Transition time study

Transmitter transition time in Clauses 193 and 194 — the further work invited by comment #102

IEEE P802.3ds D1.2, 200 Gb/s per Wavelength MMF PHYs Task Force

Bill Simms, Piers Dawe, NVIDIA

Comment #102 against D1.1, and its disposition

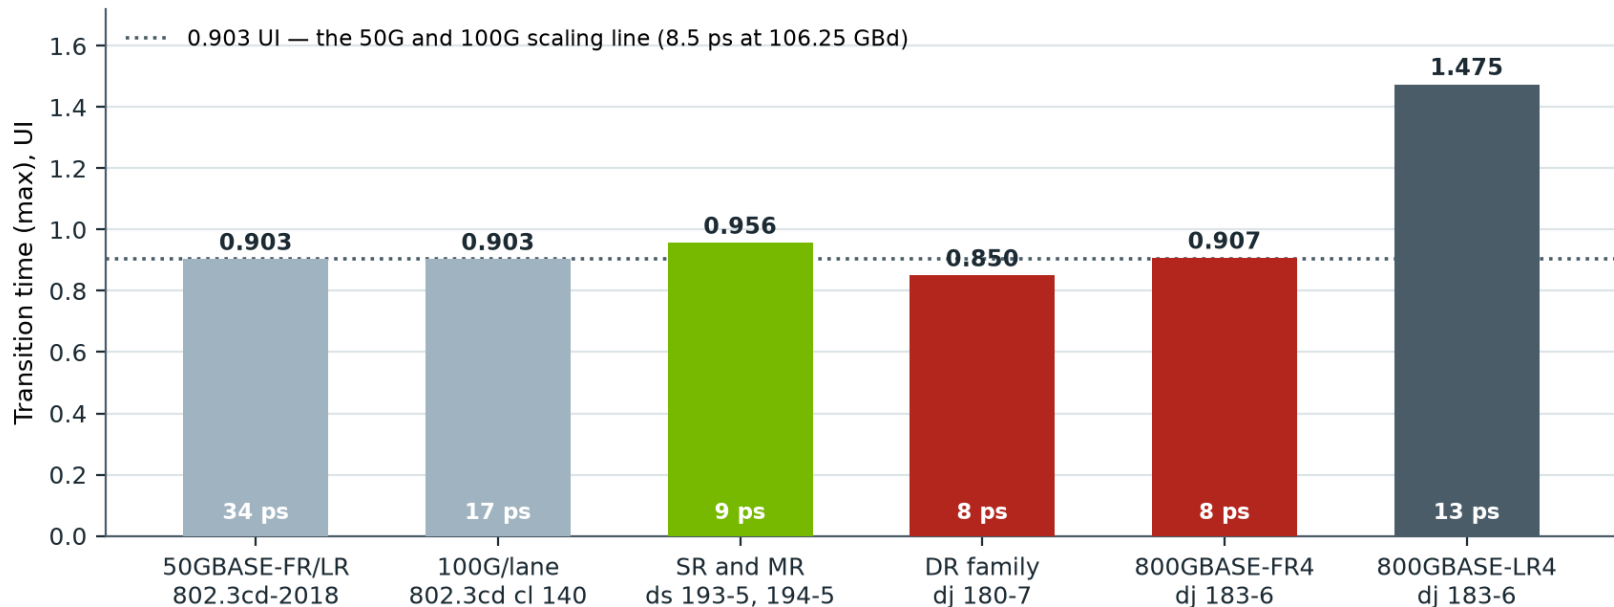
Dawe, NVIDIA — CI 193, SC 193.7.1, P59 L39, type TR [2]

- **The ask.** Delete the transmitter transition time row from Table 193-5, delete 193.9.12, and delete the corresponding row in the mapping of parameters to test patterns.
- **The stated basis.** The limit “was scaled from 50G (34) then 100G (17) where a product receiver with FFE-based or other linear equalization was considered”. Today's receivers have DSP and tolerate slow signals well.
- **The principle.** “This is a specification; we specify outcomes, not possible causes. A signal that the ECQ equaliser finds difficult to equalise, gets a bad rating anyway.” Transition time is a cause; TDECQ and TECQ are the outcome.
- **The disposition.** REJECT — “Tx transition time has been retained as a parameter in 200G per lane DR links. Further work on this topic is encouraged.”

Two observations about the response. First, it does not defend the value; it observes that P802.3dj retains the parameter — a value itself under challenge in comments R2-195 and R2-200 [8]. Second, it explicitly invites further work [2]. This contribution supplies the quantitative backing that comment #102 asserted but did not carry. One drafting note if the comment is re-filed against D1.2: the remedy cites “Table 193-13, Mapping of parameters to test patterns”, which D1.2 renumbered to Table 193-11; 193-13 is now the reference equalizer coefficient constraints [1].
